Urban Perspectives Ltd
PO Box 9042
Marion Square
Wellington 6141

TDG Ref: 12834.001
13 March 2015

**North Kumutoto Precinct Project
Response to Traffic Matters Raised by Soon Kong**

Kumutoto Precinct: Site 10 and Open Space Development
 Loading Bay Manoeuvres

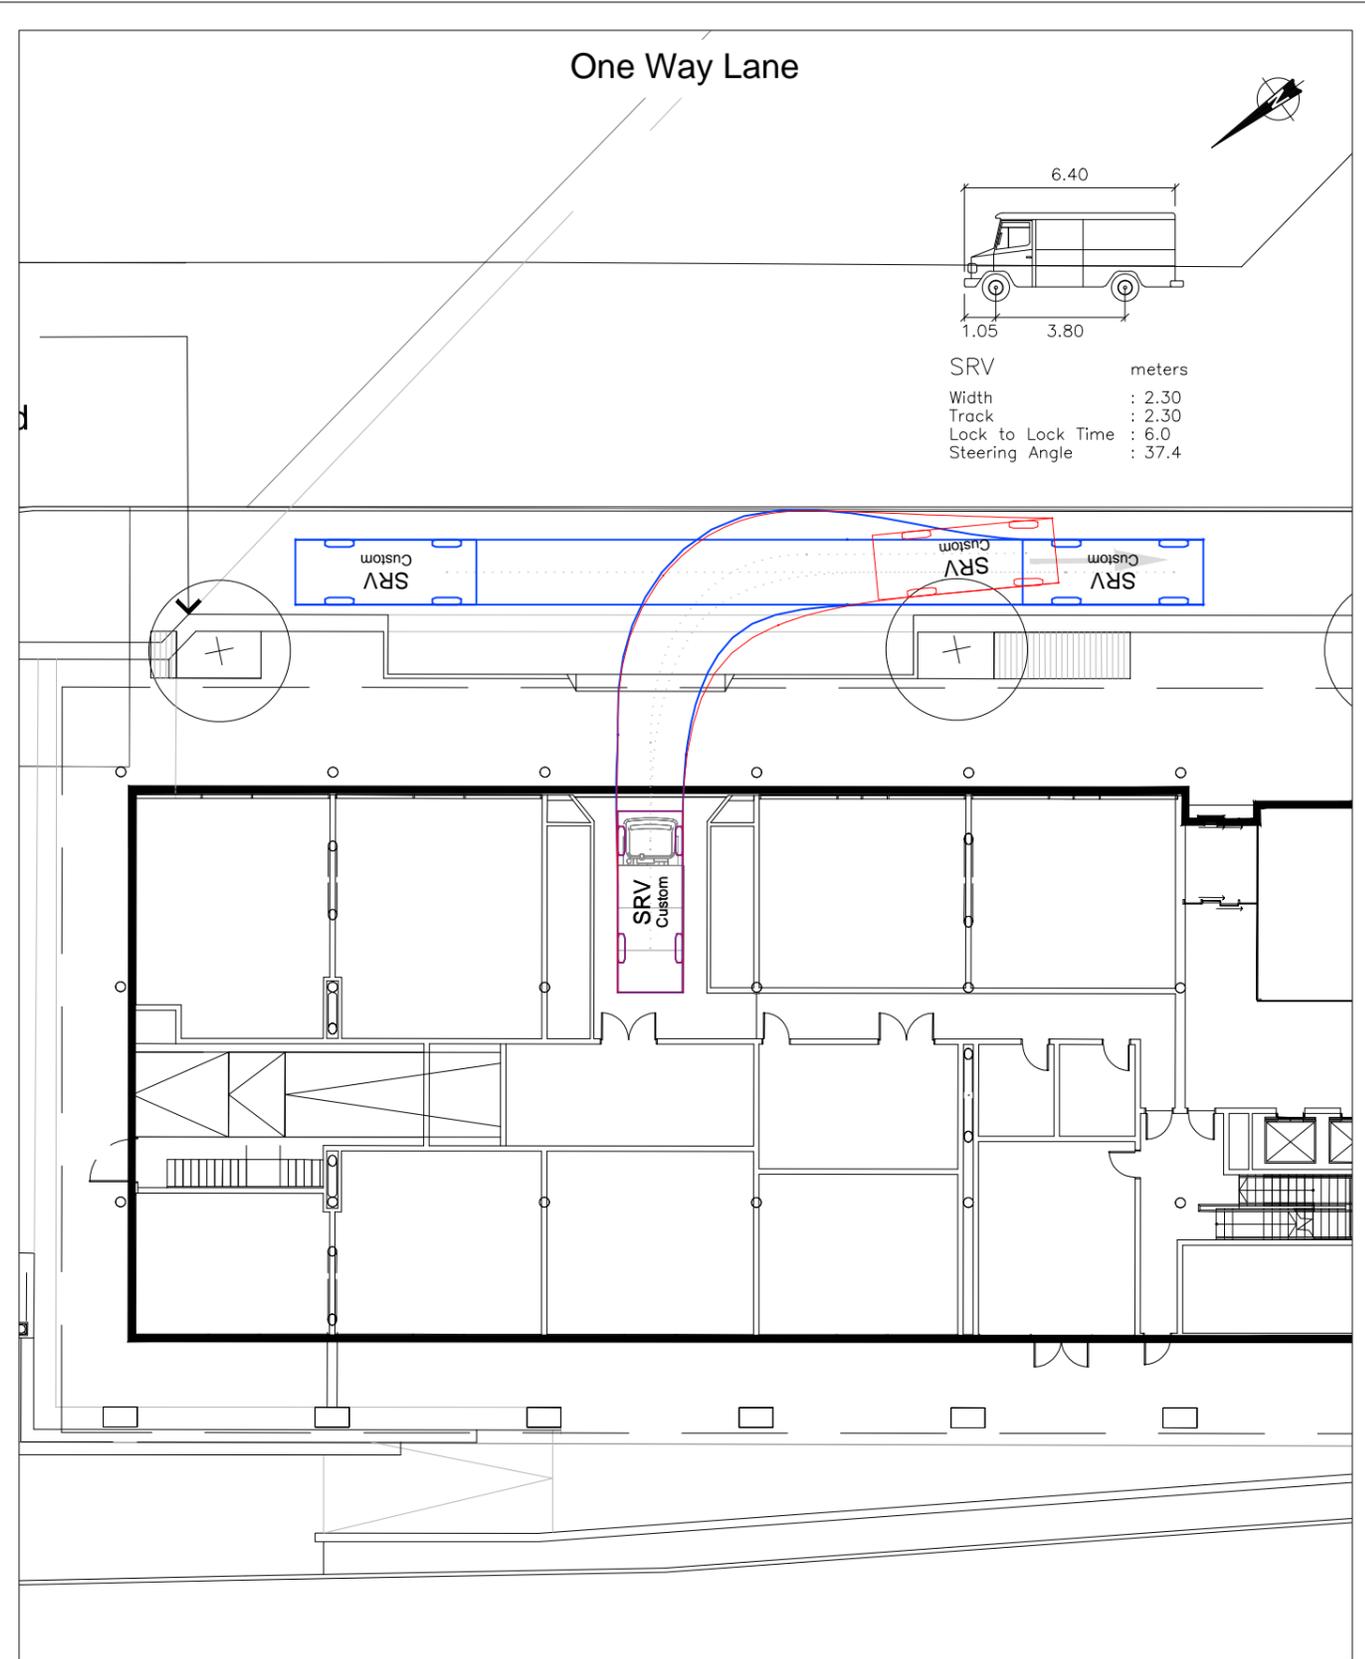
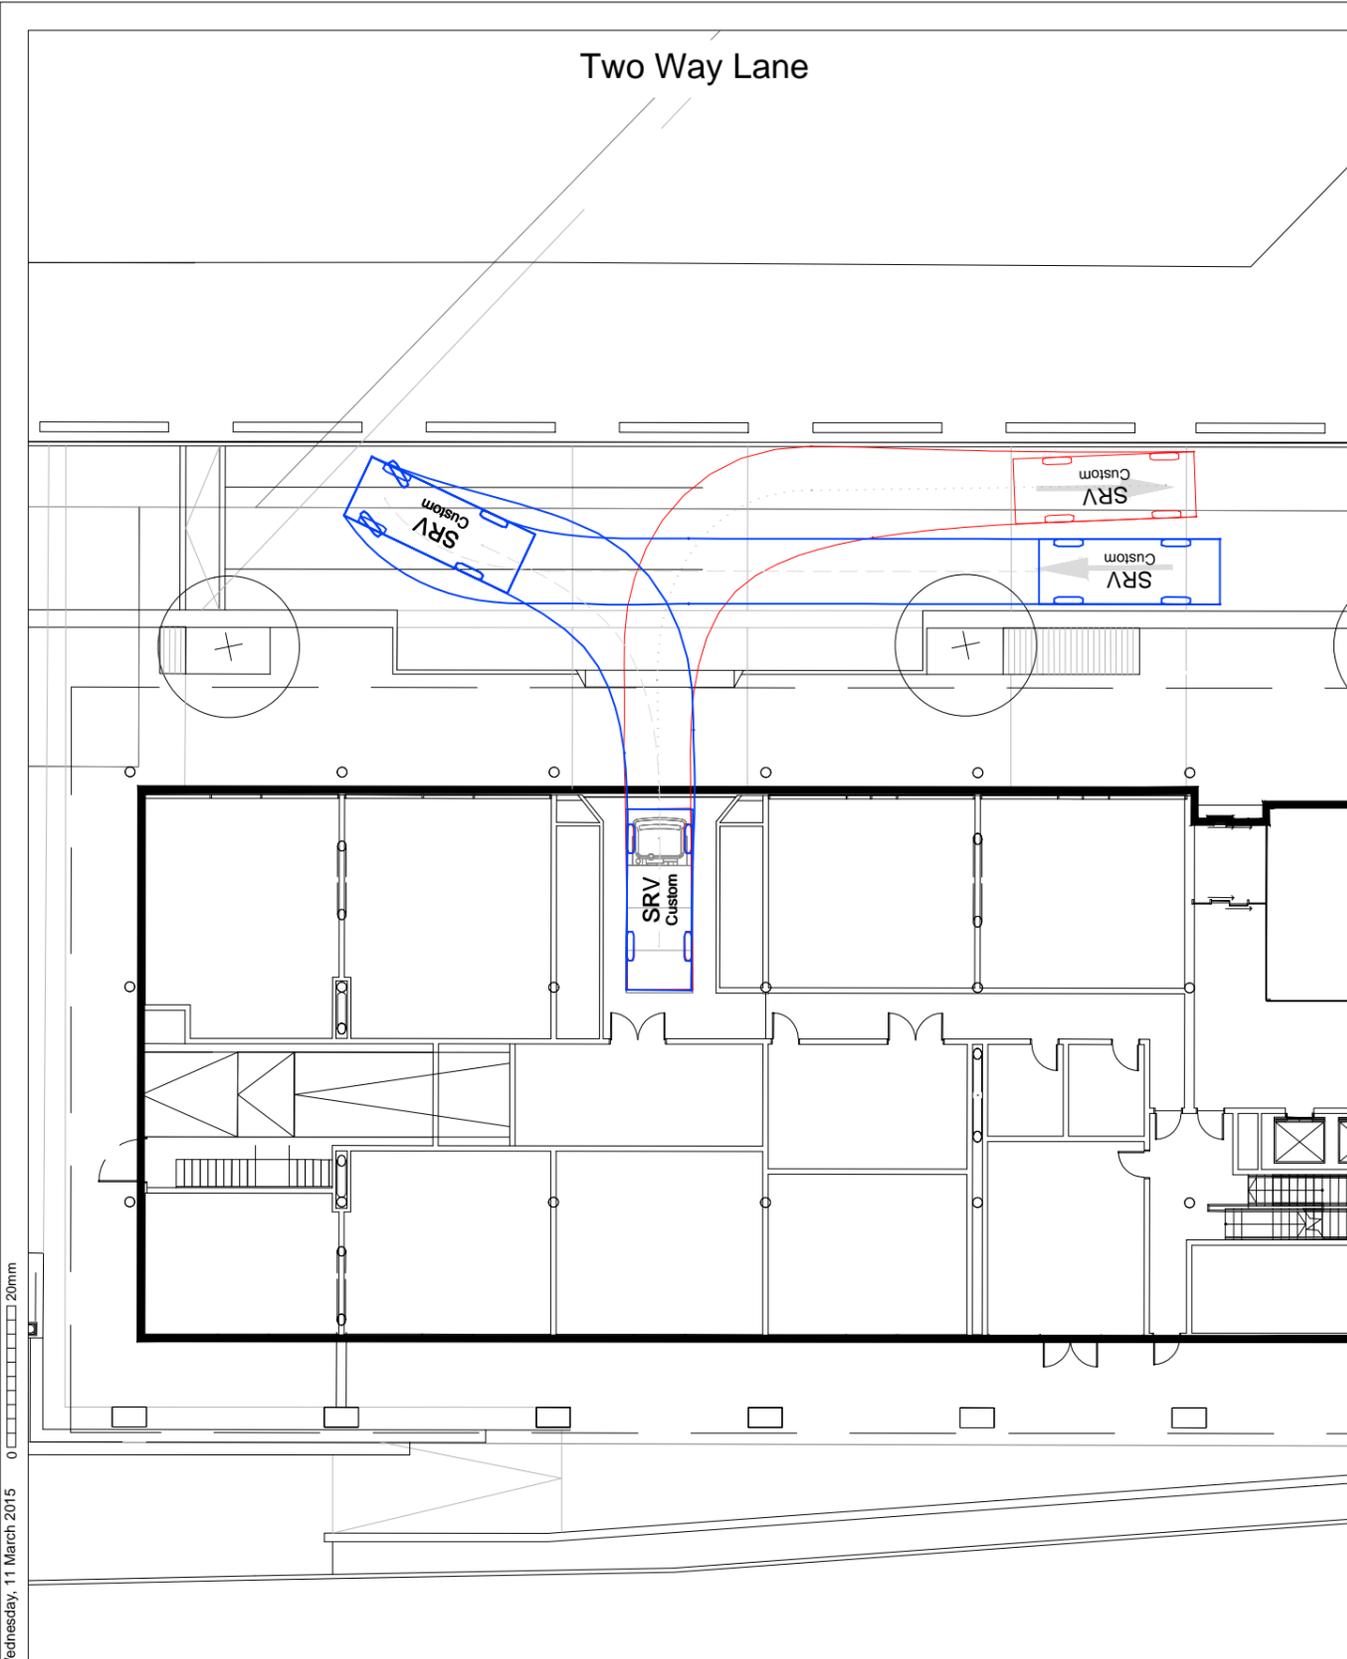
- *Item 21. The proposed cycle entry gate is to be designed in order not to compromise the visibility splay in Drawing SK_06_C.*
- *Item 22. With a one-way lane, a reversing service vehicle will track over a large area of footpath. This needs to be addressed to ensure that truck manoeuvring is restricted to the vehicle crossing e.g. bollards along the kerbedge.*

In conjunction with further consideration of the location and design of the kerbside loading zone, access to and from the internal loading bay has been reviewed, and a revised Figure 7b prepared to illustrate the revised truck access and turning, as attached, again for the two-way and on-way lane options.
